Design Schematics for a Sustainable Parking Lot

**Building 2-2332, ENRD Classroom,
Fort Bragg, NC**

Final Report

Figure 22. Scheme C (not to scale) — both aesthetically and technically pleasing, but uses significantly more pavement.

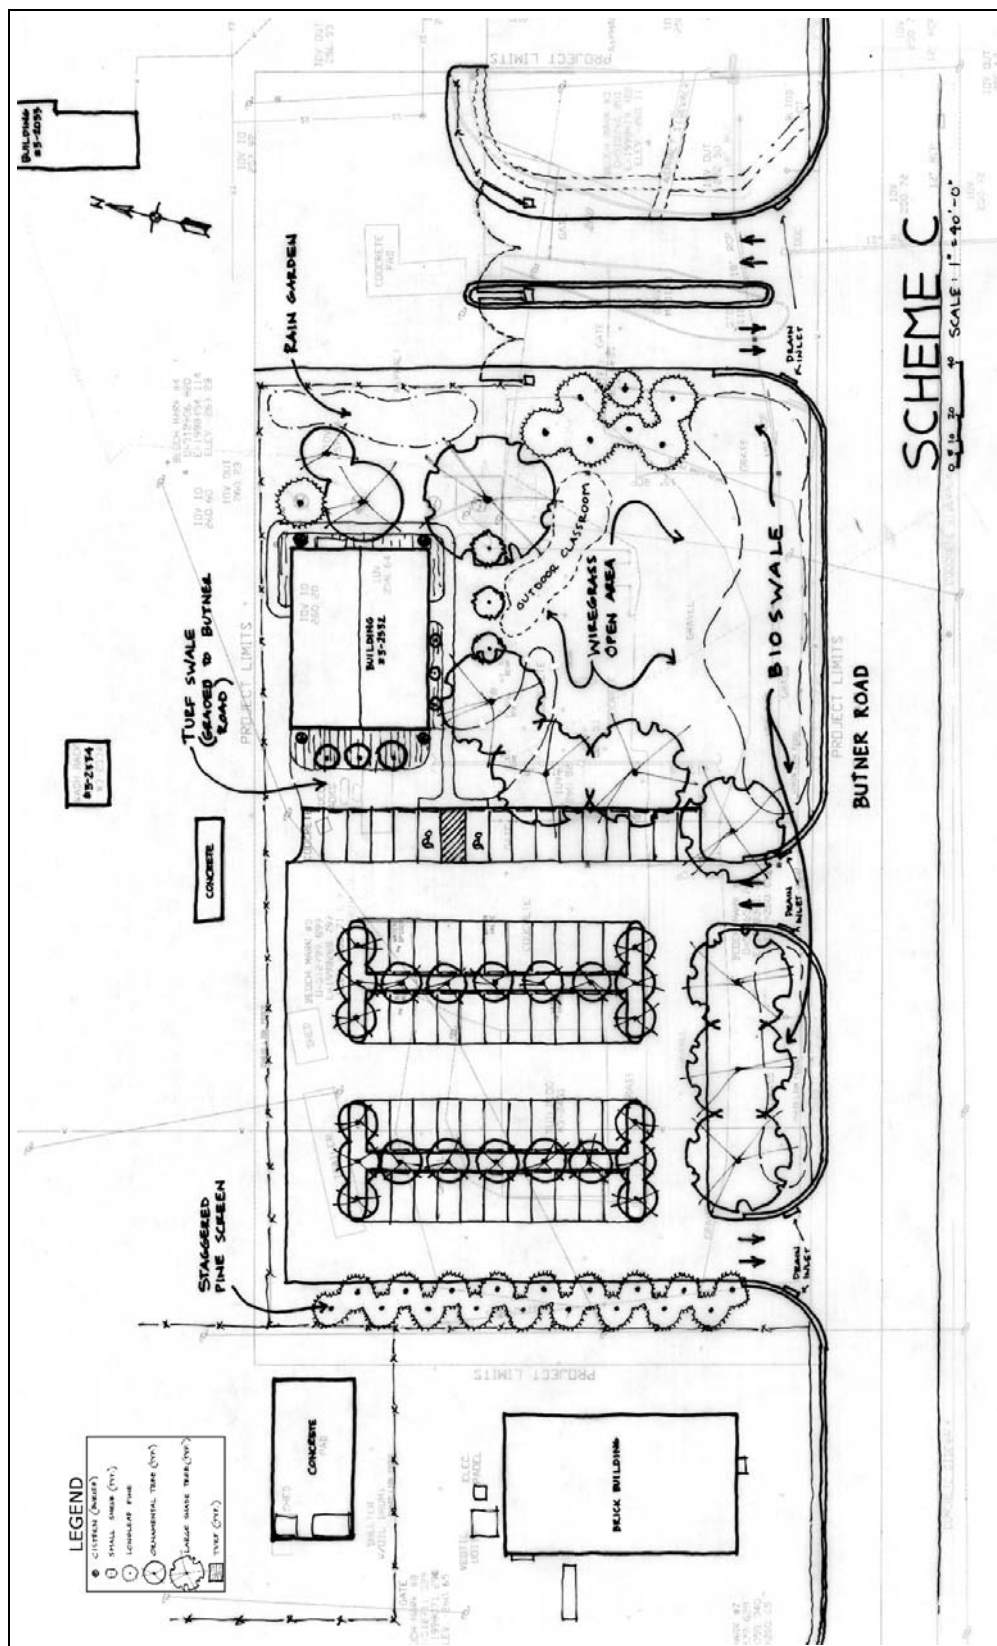
14. Scheme C – need to address pedestrian traffic coming from within the PWBC compound. Add a pervious walkway to the side or front door. Consider adding a sidewalk inside the fence.

Figure 27. Schematic Design "C" with installation comments.

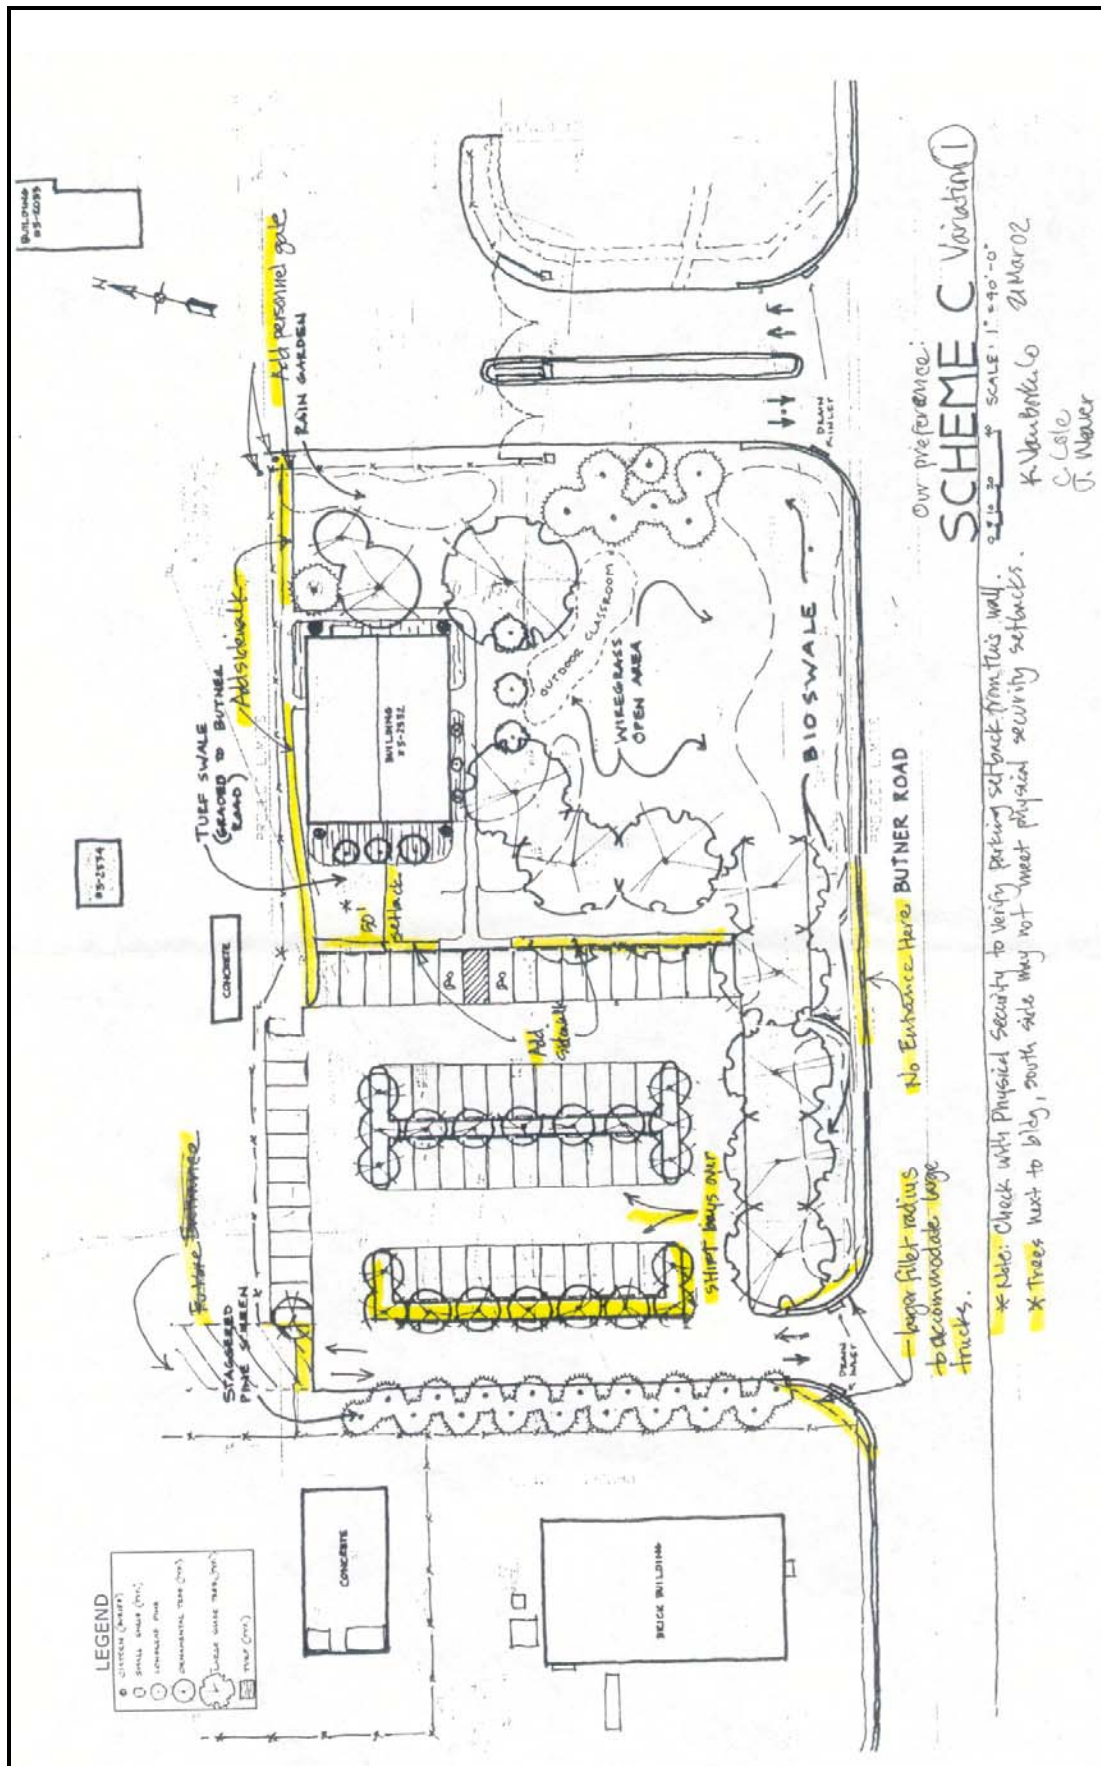
16. Add a bike rack and motorcycle parking.
17. There are drain inlets shown on the driveways. Should be a culvert underneath that has a grate or slit-drain on top to catch any runoff from the parking area. Culvert should dump water into the bioswale or into the underground retention tanks.
